10/530,463

Geoffrey D Brown

Office Action Summary

DETAILED ACTION

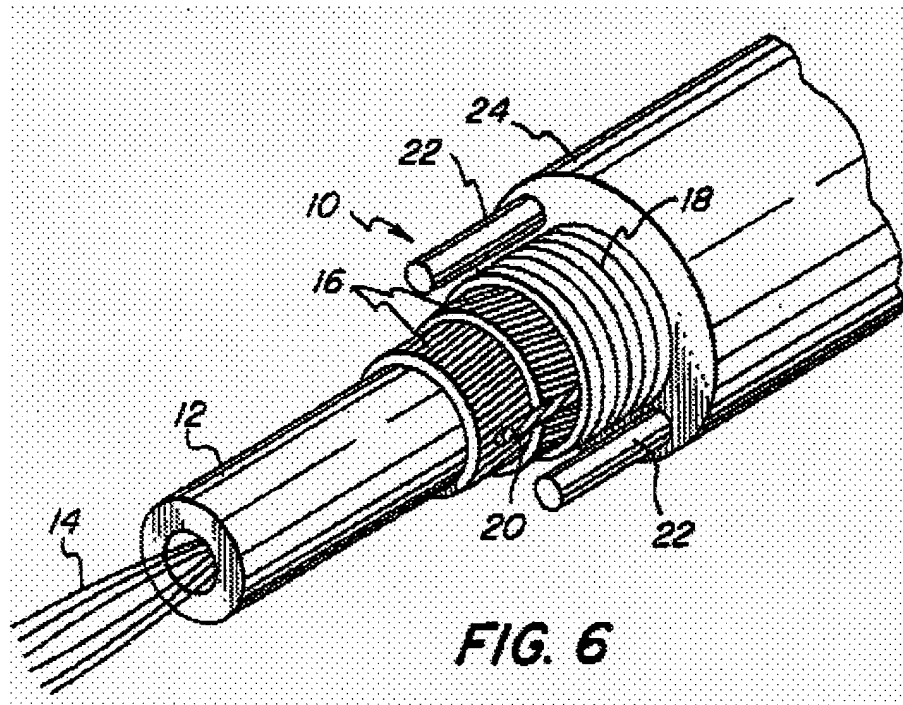
In re claims 1 and 3-6, Risch discloses an optical fiber cable 10 comprising a protective buffer tube 12 and at least one optical fiber transmission medium 14. Risch further teaches that the buffer tube 12 can be made using extruded blends of polypropylene (e.g., see Risch at the Abstract). Figure 6 of Risch is reproduced below.

Thus, Risch only differs from claims 1, 3, and 5-6 in that Risch does not teach using an extruded blend comprising the composition set forth by claims 1 and 3. Harrington, as mentioned above, teaches an extruded blend comprising all the limitations of claims 1 and 3. The motivation to use the extruded blend of Harrington to manufacture the buffer tubes of Risch is obtain improved elastic recovery and toughness. See Harrington at the Abstract. Therefore, it would have been obvious to one of ordinary skill in the art at the time of the claimed invention to obtain the invention specified by claims 1, 3, and 5-6 in view of Risch combined with Harrington.
